DAVIS-BESSE
IMPROVED TECHNICAL
SPECIFICATIONS CONVERSION

ITS SECTION 3.4
REACTOR COOLANT SYSTEM (RCS)

**ITS 3.4.1, RCS PRESSURE, TEMPERATURE, AND FLOW
DEPARTURE FROM NUCLEATE BOILING (DNB) LIMITS**

**Current Technical Specification (CTS) Markup
and Discussion of Changes (DOCs)**

3.4.1 RCS Pressure, Temperature, and Flow Departure from Nucleate Boiling (DNB) Limits

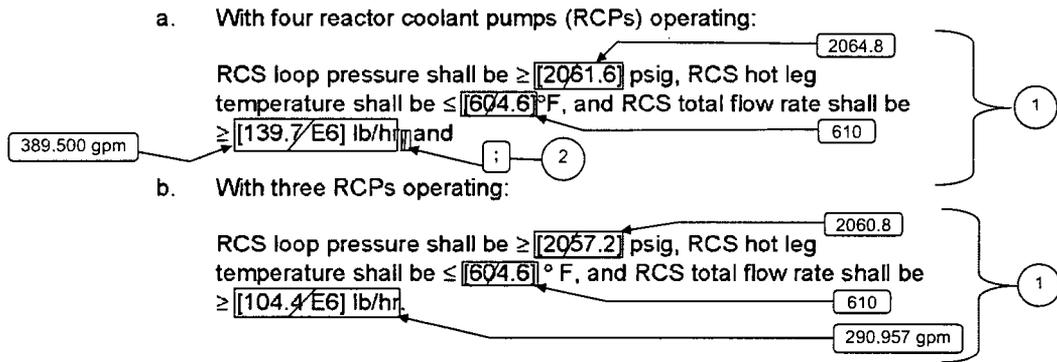
4.2.5.1		<p>Verify RCS loop pressure \geq $\boxed{2061.6}$ psig with four RCPs operating or \geq $\boxed{2057.2}$ psig with three RCPs operating.</p> <p><i>(Annotations: 2064.8, 2060.8)</i></p>	12 hours	<p>① ①</p>
Table 3.2-2 Note (1)	SR 3.4.1.2	<p>-----NOTE----- With three RCPs operating, the limits are applied to the loop with two RCPs in operation.</p>

4.2.5.1		<p>Verify RCS hot leg temperature \leq $\boxed{604.6}$ °F.</p> <p><i>(Annotation: 610)</i></p>	12 hours	①
4.2.5.1	SR 3.4.1.3	<p>Verify RCS total flow \geq $\boxed{139.7 \text{ E6}}$ lb/hr with four RCPs operating or \geq $\boxed{104.4 \text{ E6}}$ lb/hr with three RCPs operating.</p> <p><i>(Annotations: 389,500 gpm, 290,957 gpm)</i></p>	12 hours	<p>① ① ③</p>

4.2.5.2	SR 3.4.1.4	<p>-----NOTE----- Only required to be performed when stable thermal conditions are established in the higher power range of MODE 1.</p> <p>Verify RCS total flow rate is within limit by measurement.</p>	$\boxed{18}$ months	<p>④ ①</p>
		<p>Not required to be performed until 7 days after stable thermal conditions are established at \geq 70% RTP.</p>

1. Brackets have been removed and the proper plant specific information/value has been provided.
2. These punctuation corrections have been made consistent with the Writer's Guide for the Improved Standard Technical Specifications, TSTF-GG-05-01, Section 5.1.3.

3. Typographical error corrected.
4. The ISTS SR 3.4.1.4 Note currently requires performance of the SR immediately upon establishing stable conditions in the higher power range. The proposed change removes the ambiguity of "higher power range" by using a specific power level requirement. Also, as described in ISTS Section 1.4, Example 1.4-5, the wording of the Note regarding stable thermal conditions means that it must be completed when stable conditions are established. No time is provided after the establishment of stable conditions. The Note has been revised to allow some time after the "stable thermal conditions are established in the higher power range of MODE 1" to actually perform the measurement. Therefore, the Note is revised to allow 7 days after stable thermal conditions are established at $\geq 70\%$ RTP. This is consistent with the current manner in which Davis-Besse performs the Surveillance, since it provides the necessary time to allow test procedure completion and calculation verifications.

Figure 3.4.12-1
RCS Pressure Versus Pressurizer Level Limit
for Inoperable DHR System Relief Valve in MODE 4

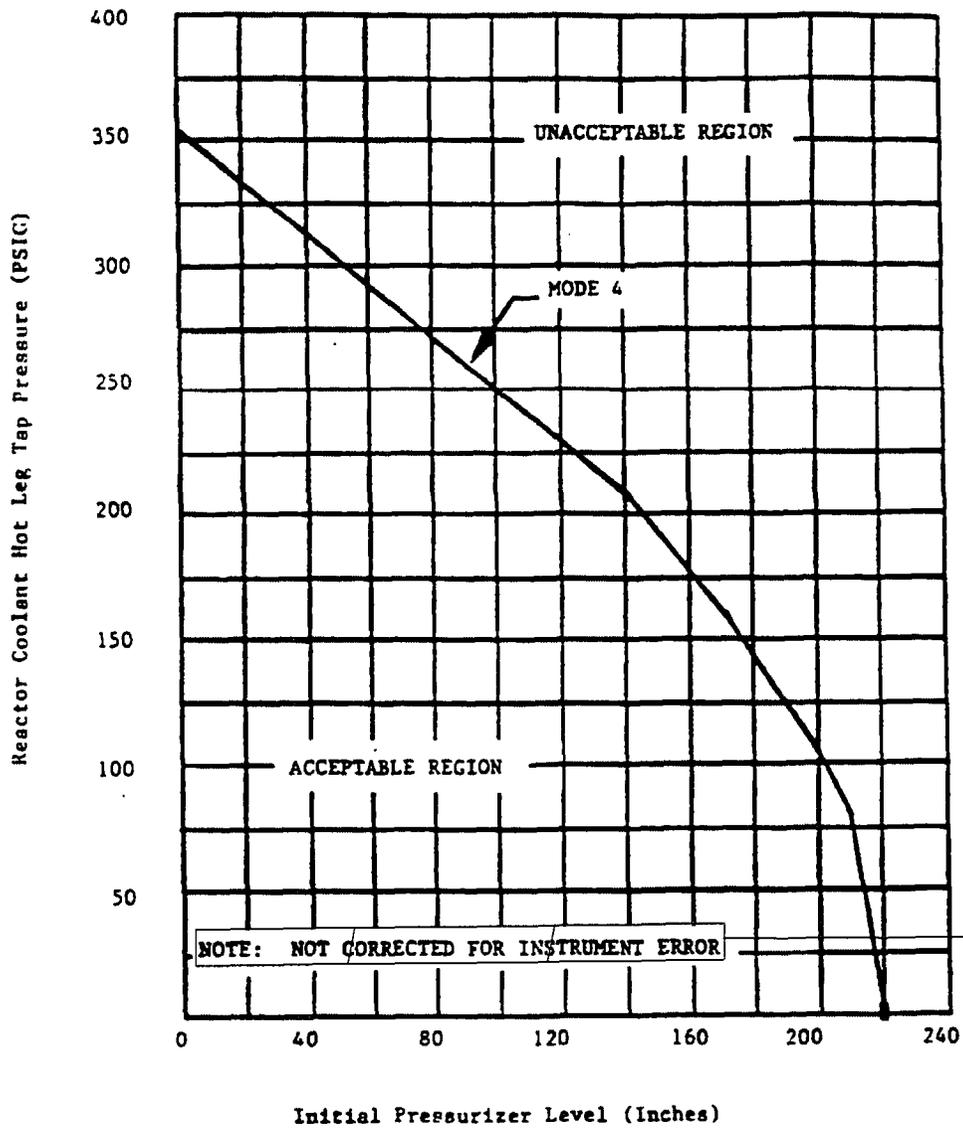
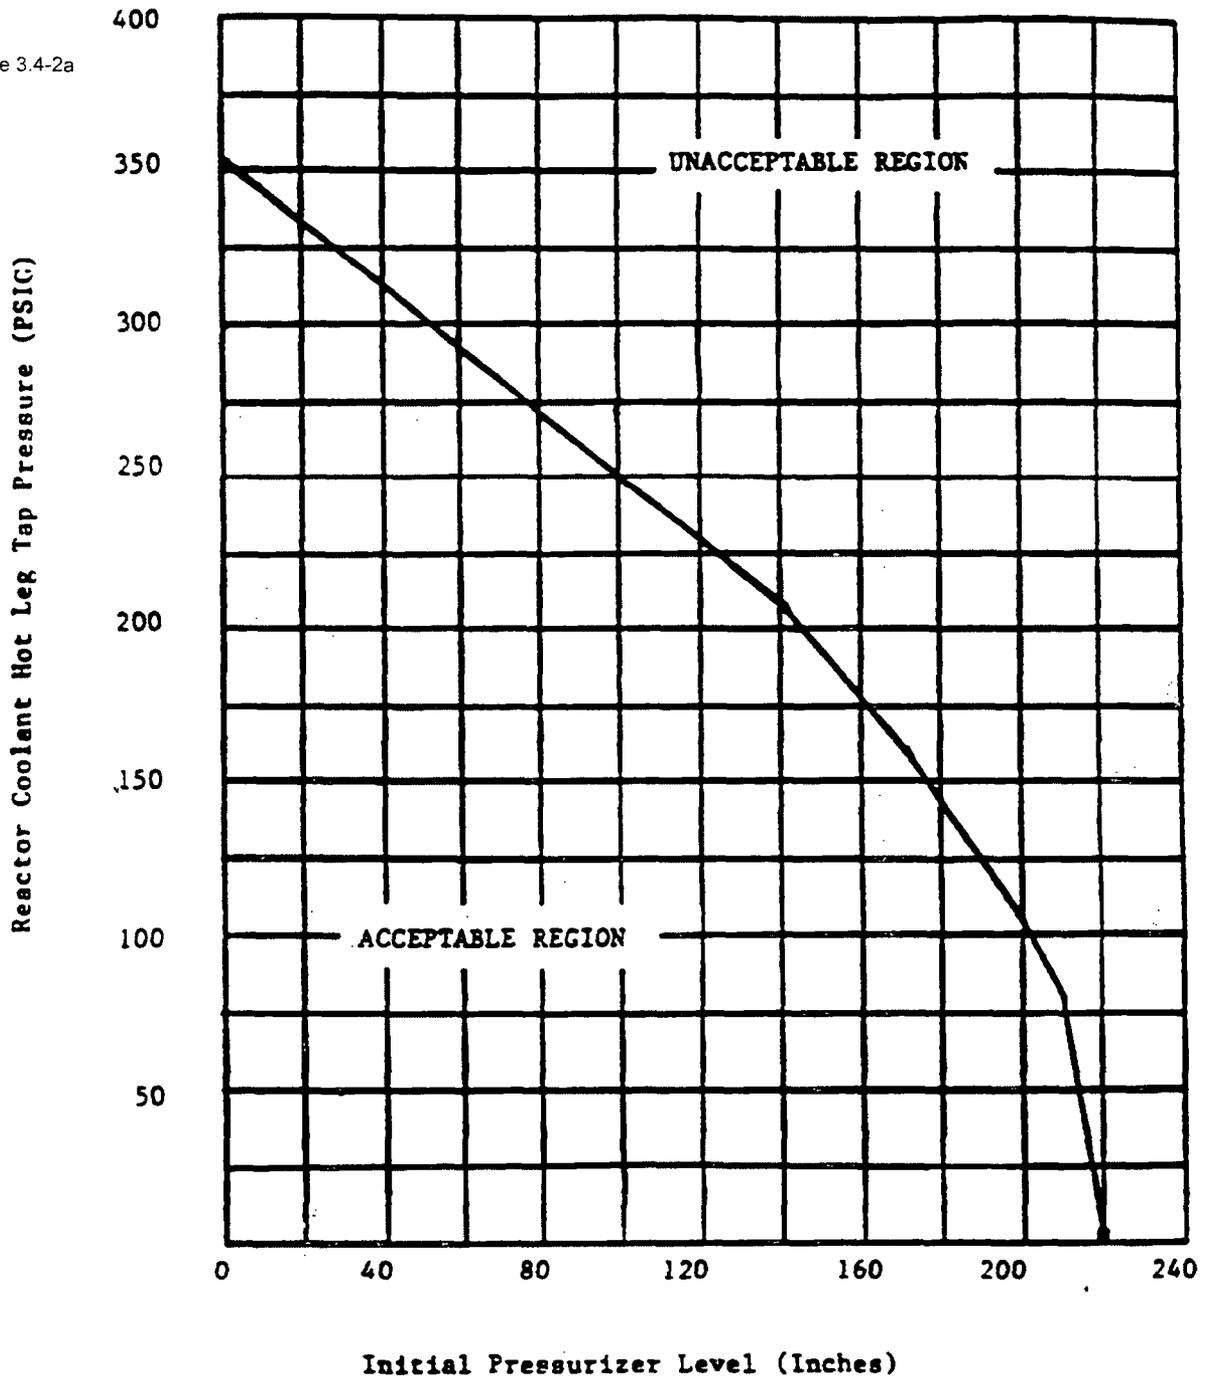
- M01 CTS 3.4.2 is applicable in MODES 4 and 5. CTS Figure 3.4-2b is applicable in MODE 5. ITS LCO 3.4.12 is applicable in MODES 4 and 5, and MODE 6 when the reactor vessel head is on. In addition, Figure 3.4.12-2 is applicable in MODE 5 and MODE 6 when the reactor vessel head is on. This change expands the Applicability of the low temperature overpressure protection components to be OPERABLE in MODE 6 when the reactor vessel head is on.

Figure 3.4.16-1 (page 1 of 1)
Reactor Coolant DOSE EQUIVALENT I-131 Specific Activity Limit
Versus Percent of RATED THERMAL POWER With Reactor Coolant
Specific Activity >1.0 µCi/gm DOSE EQUIVALENT I-131

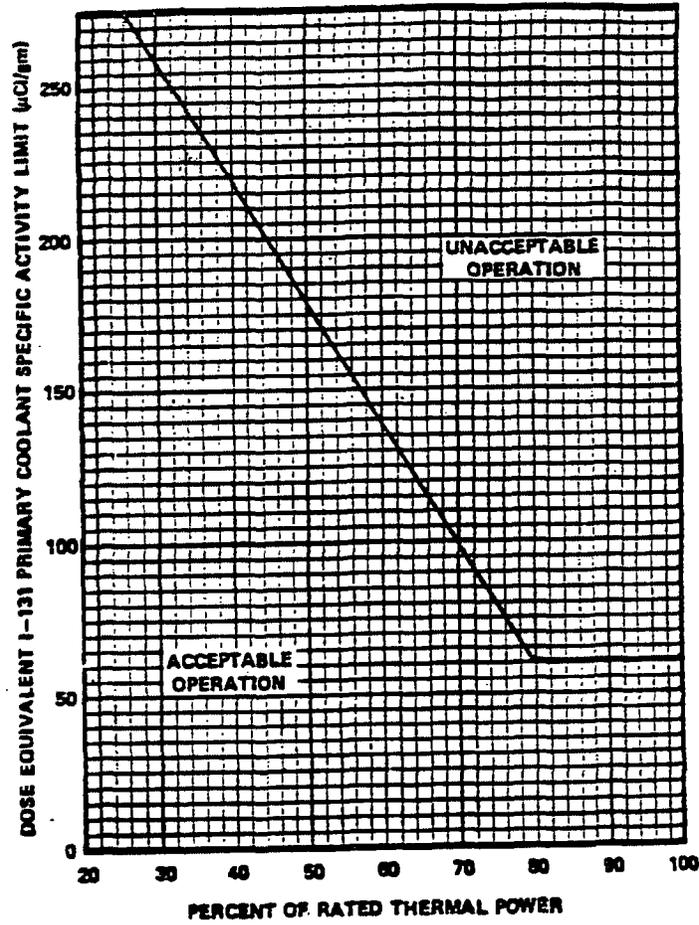
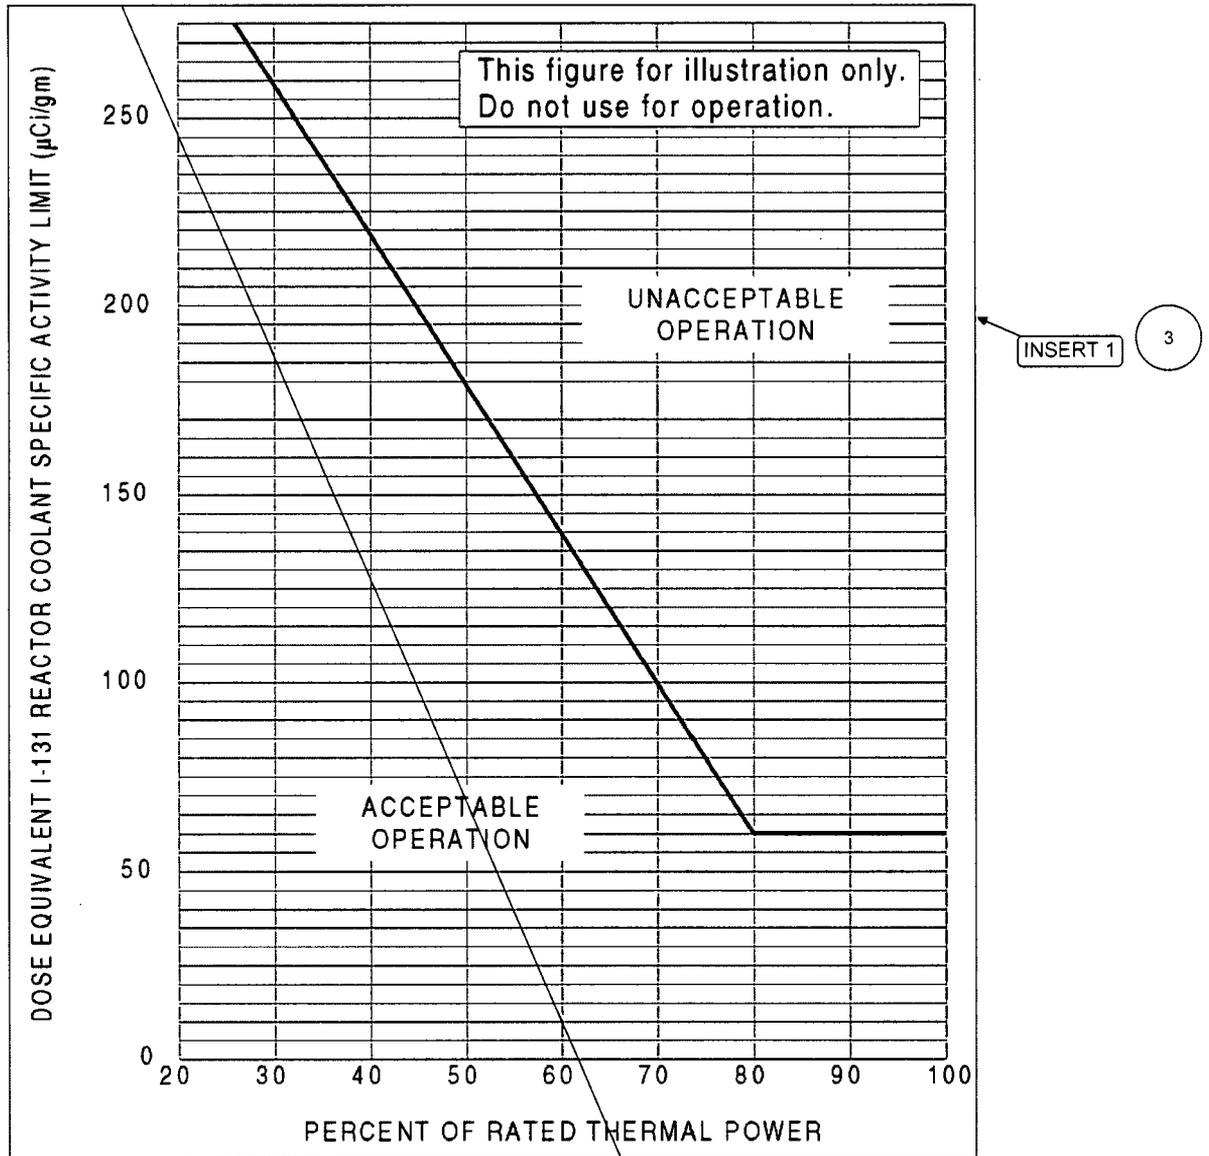
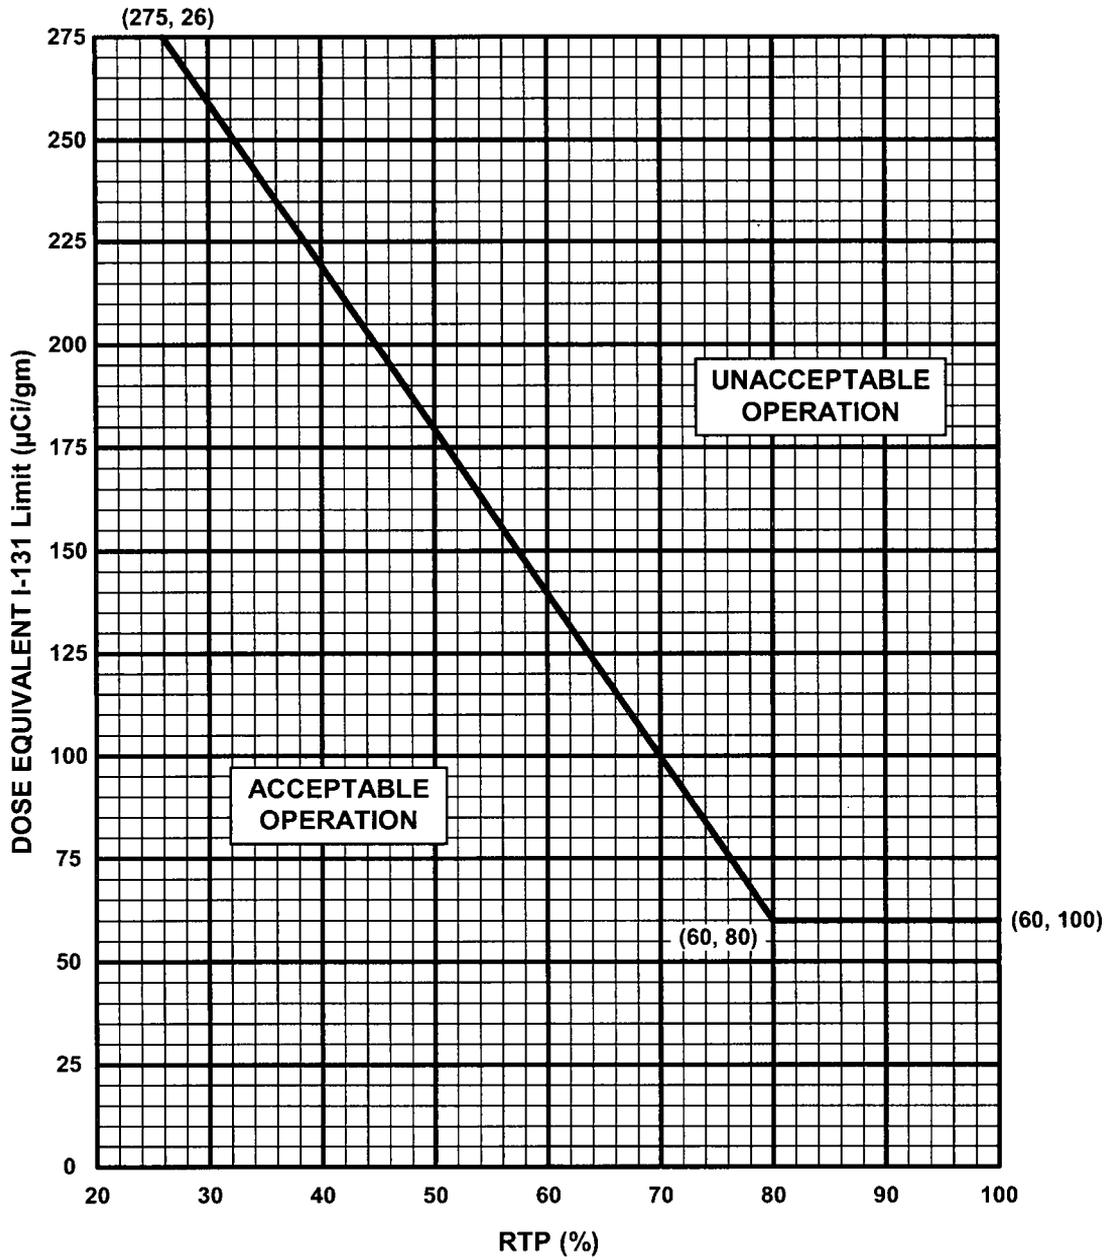
a. With the specific activity of the primary coolant $> 1.0 \mu\text{Ci}/\text{gram}$ DOSE EQUIVALENT I-131 for more than 48 hours during one continuous time interval or exceeding the limit line shown on Figure 3.4-1, be in at least HOT STANDBY with $T_{\text{avg}} < 530^\circ\text{F}$ within 6 hours.
